Access Compliance Report

Public Rights-of-Way

(Curb Ramps)

Intersection ID: 43744	Main Street: RED_CLAY_LN	Cross Street: EARTHENWARE_DR	Location:	N
ADA ID: A930626EA863	Ramp Type: PerpDiag	Initial Pass/Fail: Fail	Overall Compliance: No	Severity Score: 35

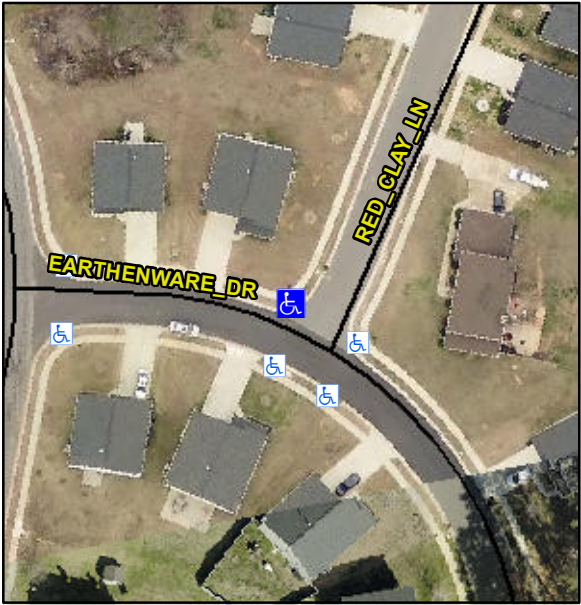
Codes/Mitigation Info/Possible Solution			Field Measurements/Component Compliance		
	Possible Solutions:		Compliance	Description	Data
	Remove & Replace Curb Ramp With Two New Directional Ramps or Equivalent.		N/A	Ramp Length (in)	48.0
			No	Ramp Width (in)	47.0
			N/A	Flare Type LT	N/A
			N/A	Flare Slope LT (%)	N/A
			N/A	Flare Traversable LT?	N/A
			N/A	Landing Length (in)	N/A
			N/A	Landing Width (in)	N/A
			N/A	Landing Slope (%)	N/A
			N/A	Landing X Slope (%)	N/A
<p>Surveyor Notes:</p> <p>N/A</p> <p>PROW/ADA:</p> <p>Not Found, R304.5.1, R304.2.2, R304.5.3</p>			N/A	Flare Type RT	N/A
			N/A	Flare Slope RT (%)	N/A
			N/A	Flare Traversable RT?	N/A
			N/A	DWS Provided?	N/A
			N/A	DWS Contrast?	N/A
			N/A	DWS Length (in)	N/A
			N/A	DWS Full Width?	N/A
			N/A	DWS Offset (in)	N/A
			N/A	Shared Landing?	N/A
			N/A	Gutter Ponding?	N/A
			N/A	Gutter Lip Ht (in)	N/A
			N/A	Painted X Walk1?	No
				X Walk 1 Direction	To SW

N/A	X Walk 1 Width (in)	N/A
				X Walk 1 Slope (%)	3.8
				X Walk 1 X Slope (%)	0.6
			N/A	Ramp inside XWalk1?	N/A
				Road Slope (%)	2.9
				Road X Slope (%)	4.6
			N/A	Any Obstructions?	N/A
				Obstruction Type	
Total Cost:		\$ 3200.00			
			N/A		N/A
			Yes	Surface Condition? (G/P)	Good
